CONTRACT DOCUMENTS, SPECIFICATIONS
AND
CONTRACT DRAWINGS
FOR
TERREBONNE PARISH CONSOLIDATED GOVERNMENT
NORTH PLANT MAIN PUMP REPLACEMENT, A PART OF THE
NWWTP UV DISINFECTION PROJECT
PARISH PROJECT NO. 23-SEW-01

ADDENDUM NO. 2

DATE ISSUED: SEPTEMBER 29, 2025

**ADDENDUM 2
ATTACHMENT 1**

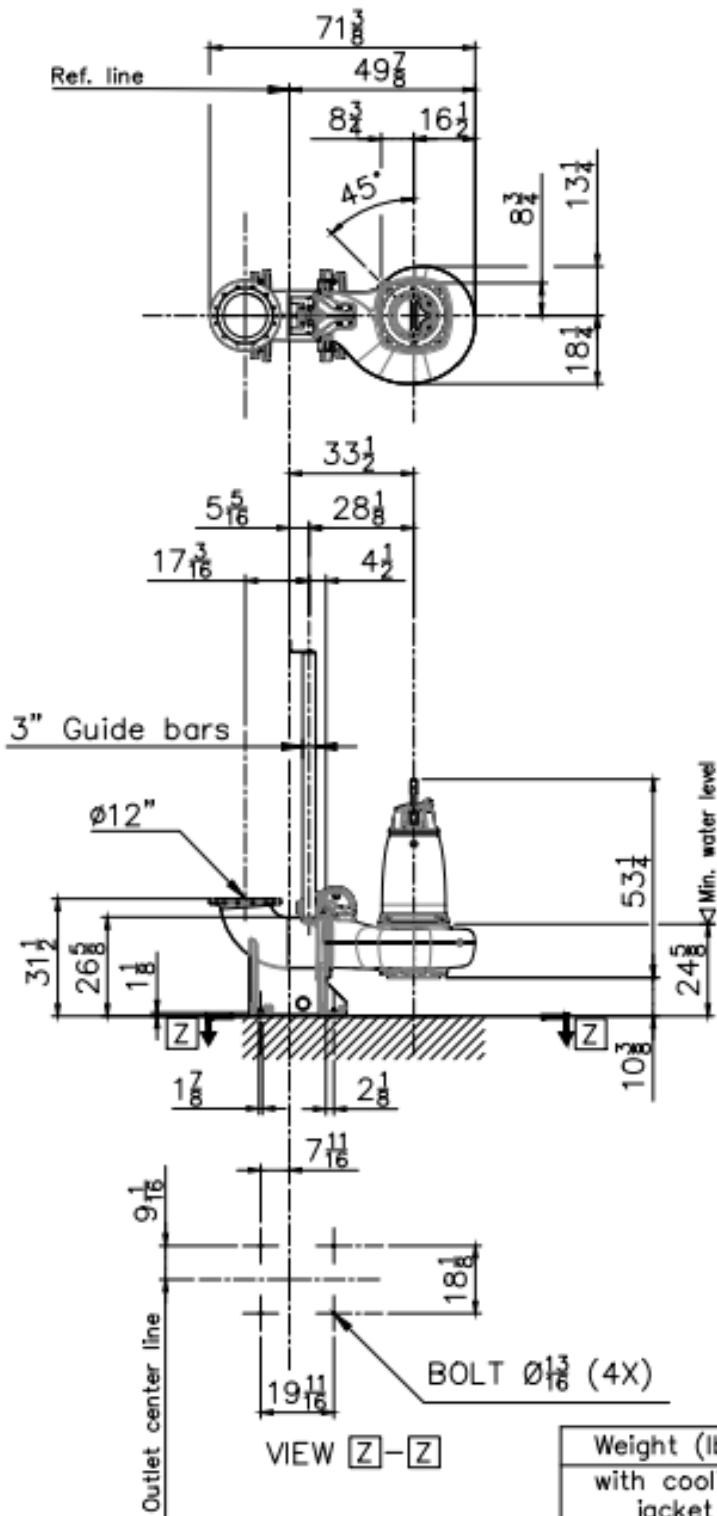
How much do the new pumps and base elbows weigh?

How long are the existing pumps?

The dimensional drawings of the new pumps are included as Attachment 1 to this Addendum 2. The drawings included the weights of the new pump discharge elbows. The new pumps include cooling jackets.

The cut sheet of the pumps is included as Attachment 1 of this addendum.
